4.0 Addendum – reinstatement of complete sundial.

St. Marys Cathedral - the inside part - B&D's. N.T.S.

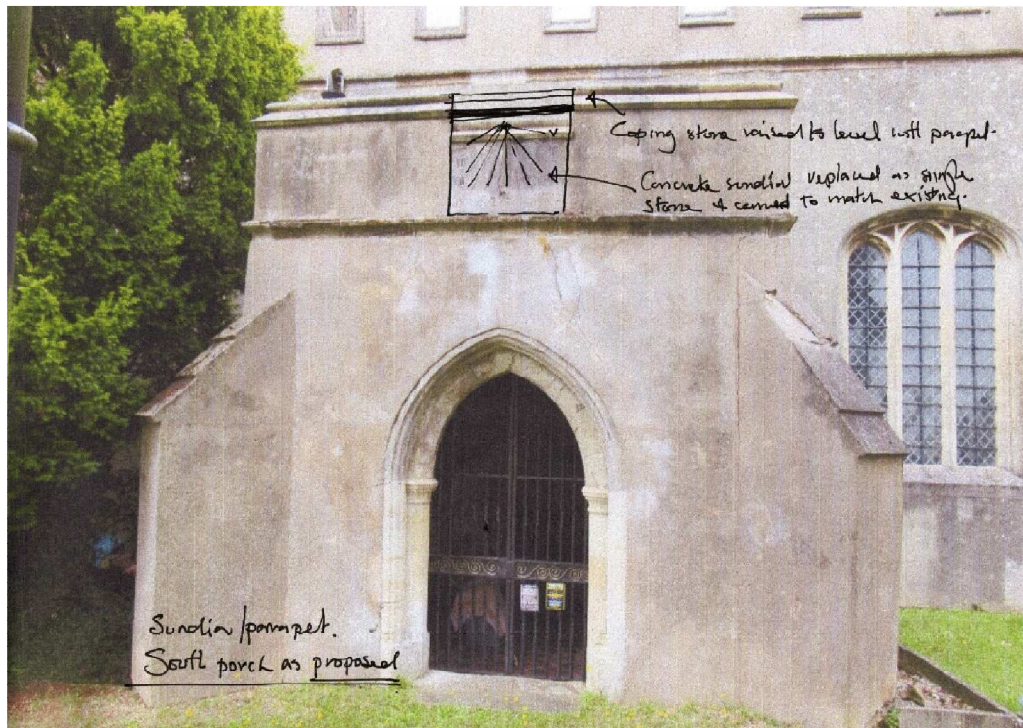
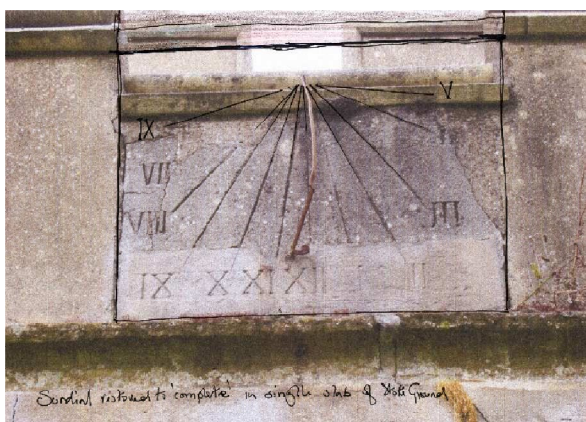
Sundial-parapet as existing (top quarter of sundial missing)

Sundial – parapet as proposed

New sundial to match existing detail and to include the missing detail as shown in sketch and photograph.

Sundial as proposed -

- and as it used to be 1994

- 4.1 Carefully remove coping stone from over sundial and set aside.
- 4.2 Record the detail on the face of the concrete sundial and remove it.
- 4.3 Repair backing brickwork and raise up in sound well burnt stock bricks level with the walls on either side. Tie into side walls with ss mesh or ss brick ties.
- 4.4 Supply and fix new sundial as single slab of Stoke Ground base bed, 50mm thick and secure to new and existing brick backing with ss dowels and a backing bedding of lime mortar.

- 4.5 Replace and seat existing coping stone to be level with coping stones on either side.
